MEMORANDUM

TO: District of Columbia Board of Zoning Adjustment
FROM: Arthur Jackson, Case Manager
 Joel Lawson, Associate Director Development Review
DATE: September 11, 2012
SUBJECT: BZA Case 18404 – Request for Special Exception relief for a concrete manufacturing facility constructed at 3 DC Village Lane SW

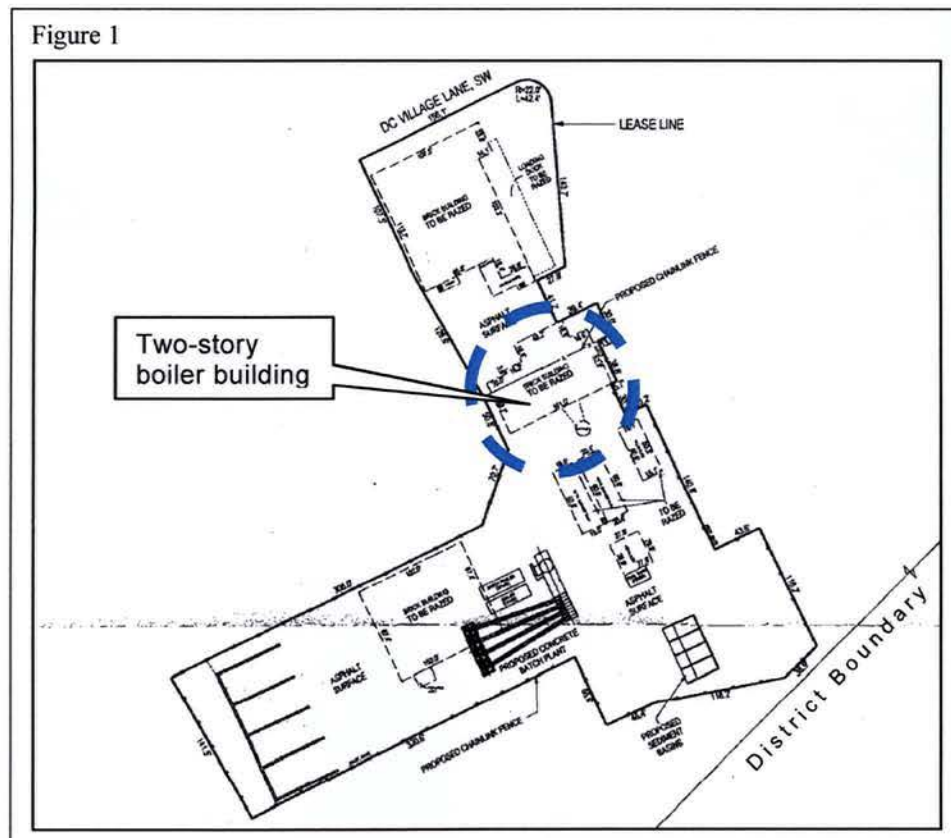
While the boiler building screens part of the site, the existing landscaping and fence are inadequate to screen the rest from the "public view" (the view from DC Village Lane). The chain link fence does not screen the plant at all and the current potted tree spacing negates their potential to effectively screen the site and parking area (refer to Exhibit 2).

The Pre-hearing Supplement indicates that an opaque covering would be added to fence portions in the "public view". Annotation on the attached landscaping plan indicated that opaque vinyl slats would be inserted into fence sections immediately north and east of the plant.

Screening just those borders is acceptable to OP because the other boundaries face other industrial uses and the MPD impound lot.² Since vinyl slates tend to fall into disrepair

over time, OP recommends the use of continuous vinyl mesh instead

- This special exception approval shall expire **7 years** from the publication date of the final Board of Zoning Adjustment (BZA) order
- Continuous opaque vinyl mesh shall be added to sections of chain link fence to the north and east of the concrete manufacturing facility

- Upon demolition of the boiler building, the chain link fence and opaque screen shall be extended across the site
- A landscape plan shall be added to the public record that creates more effective visual buffer from the “public view” as required by §§ 802 17 (g) and (h) by

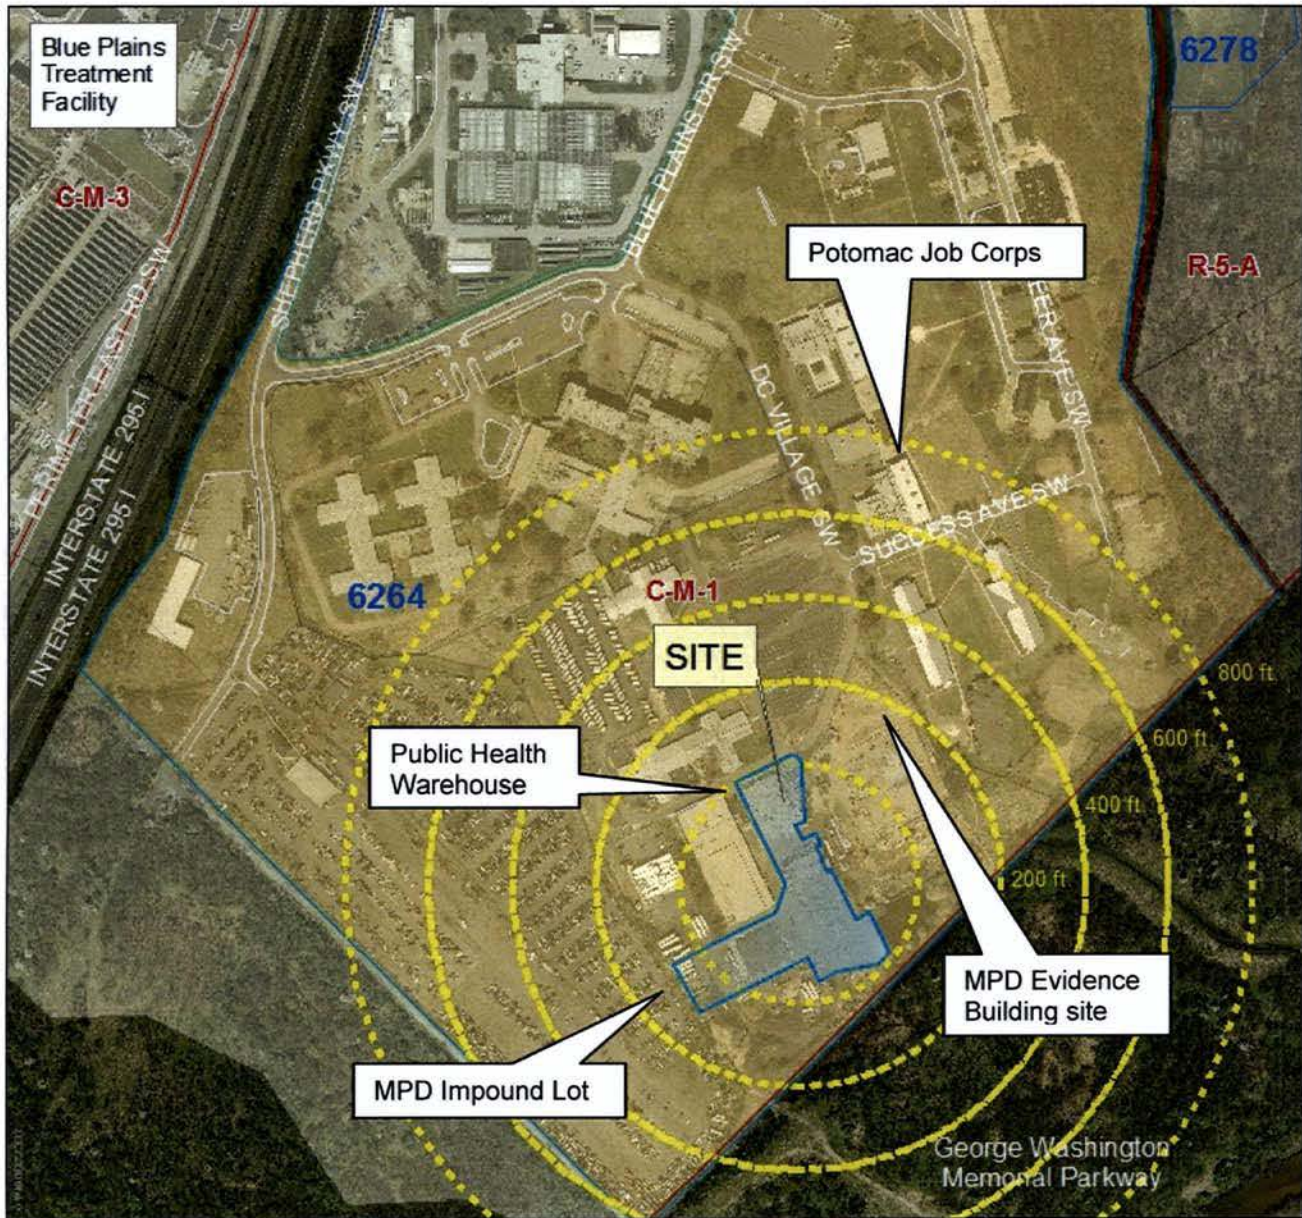
Leyland Cyprus trees are only planted along the northern boundary and public right-of-way, and a portion of the eastern site boundary (refer to Exhibit 1)

Existing potted trees are not in good health and appear to be dying

OP also observed that the plant trash dumpster, while apparently not in public space, is clearly in the “public view.” It is therefore recommended that it be relocated within the landscape buffer or opaque screen surrounding the plant

- Changing the tree species in the pots from Leyland cypress to the native juniper *Juniperus virginiana* L (Eastern red-cedar),
 - Placing additional tree planters along the fence perimeter around the plant, and

- Developing and implementing a weekly irrigation plan or entering into a signed agreement with a landscape contractor to maintain said landscaping
- A site plan shall be added to the public record showing the plant dumpster relocated from the “public view” to within the modified landscape buffer or behind the opaque screen and fence.
